PECO NUCLEAR

Subject: Limerick Generating Station Unit 2
Technical Specifications Change Request No. 99-05-0

**TECHNICAL SPECIFICATIONS CHANGE REQUEST
NO. 99-05-0**

BASES FIGURE B 3/4.3-2

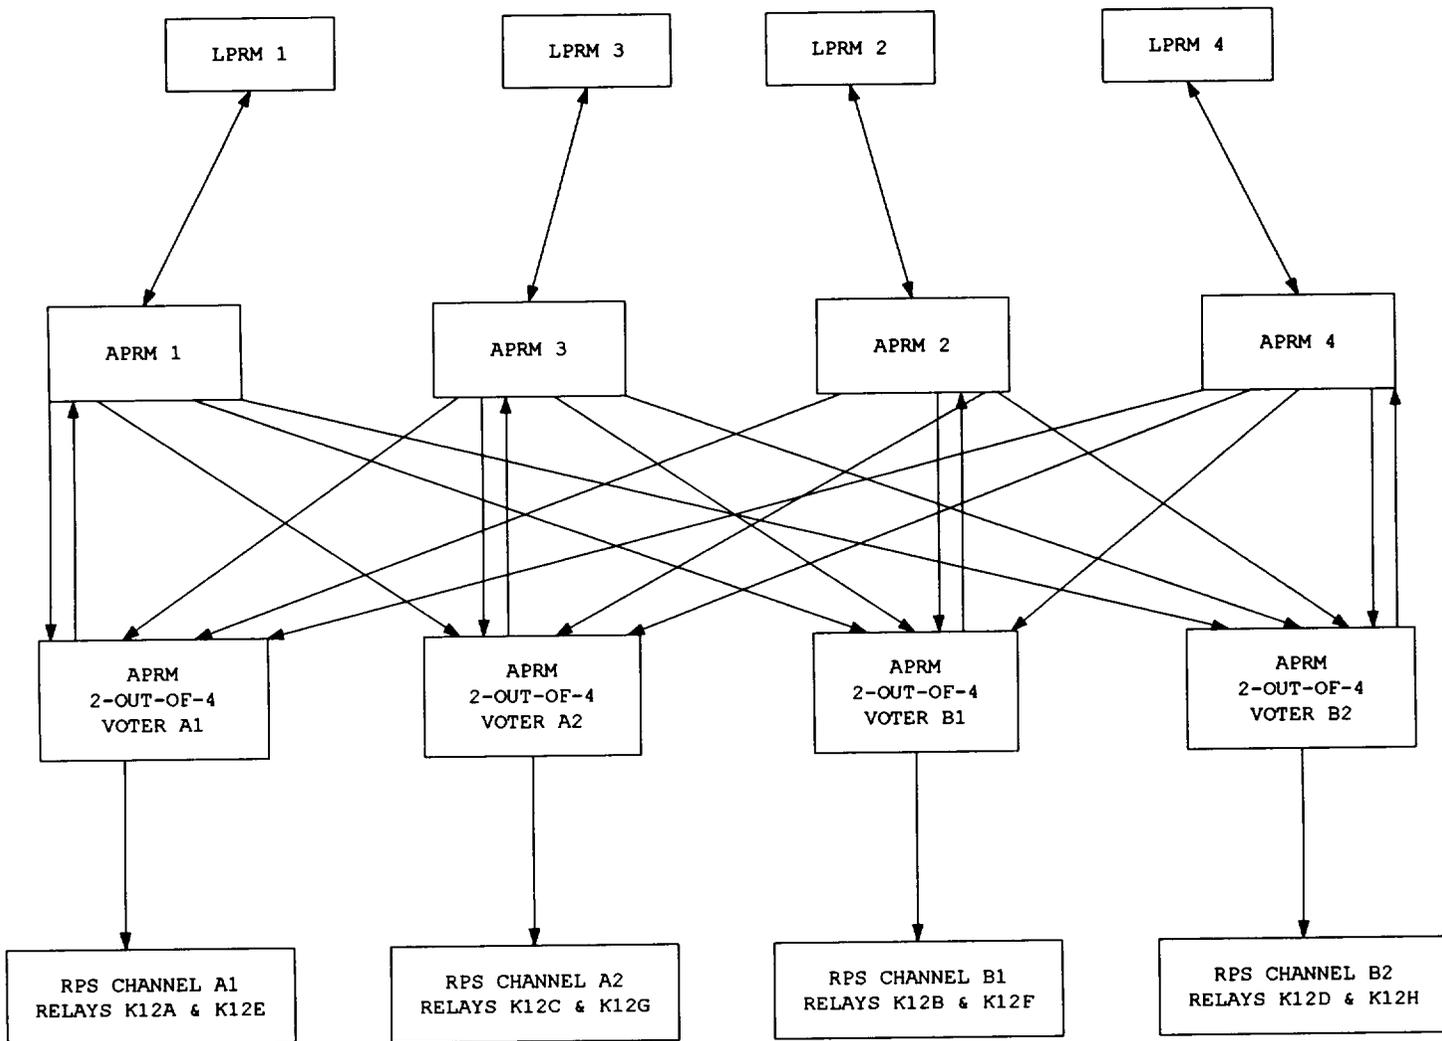
The Two-Out-Of-Four Logic Module includes 2-out-of-4 voter hardware and APRM Interface hardware. The voter Function 2.e is accomplished by the 2-out-of-4 voter hardware which includes redundant outputs. The analysis in NEDC-32410P-A took credit for this redundancy in the justification for the 12-hour allowable out of service time, so the voter Function 2.e must be declared inoperable if any of the 2-out-of-4 voter hardware's functionality is inoperable. The voter Function 2.e does not need to be declared inoperable due to any failure affecting only the APRM Interface hardware portion of the Two-Out-Of-Four Logic Module.
